Requests for Information (RFI)

RFP 2026-01 Form 470-260003525

C-Wing

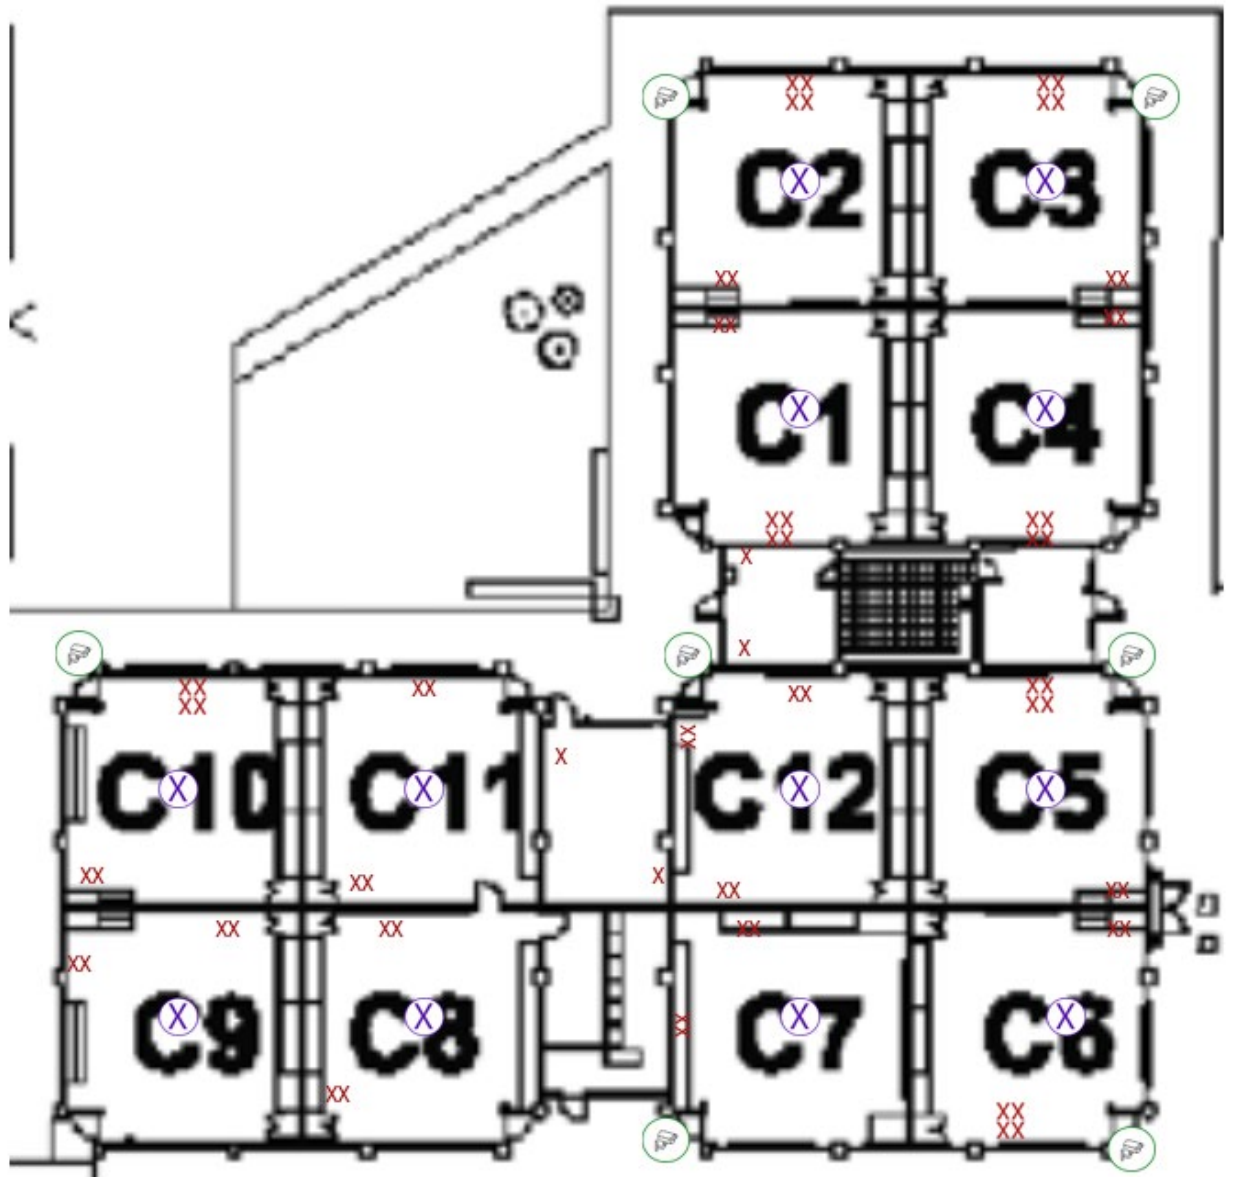
25. How many endpoints are in each classroom?

- a. Below is a list of classrooms, total number of endpoints, and a map indicating the location of each endpoint.

Room C1 – 6 endpoints

Room C2 – 6 endpoints

Room C3 – 6 endpoints

Room C4 – 6 endpoints

Room C5 – 6 endpoints

Room C6 – 6 endpoints

Room C7 – 4 endpoints

Room C8 – 4 endpoints

Room C9 – 4 endpoints

Room C10 – 6 endpoints

Room C11 – 4 endpoints

Room C12 – 6 endpoints

Cameras – 7 endpoints

Gym

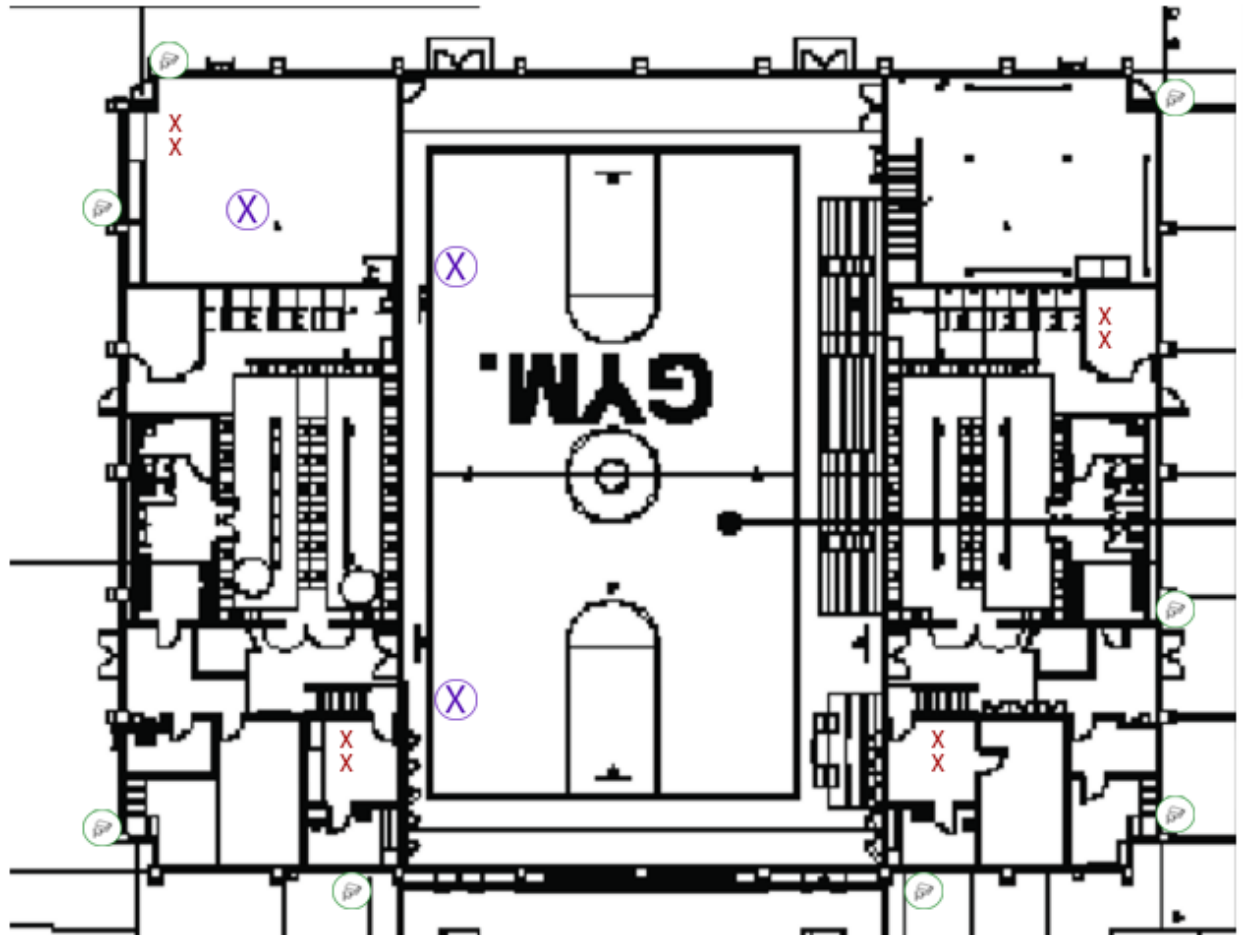
8. Where does the cabling in the Gym IDF go?
 - a. There are endpoints in the gym with very high locations. This IDF is the cabling for the whole gym. There is stair access to the roof. Please refer to Question 25.

Girl's Locker Room – 4 endpoints

Boy's Locker Room – 2 endpoints

Gym (interior) – 2 endpoints

Gym Classroom – 2 endpoints

Exterior (cameras) – 8 endpoints
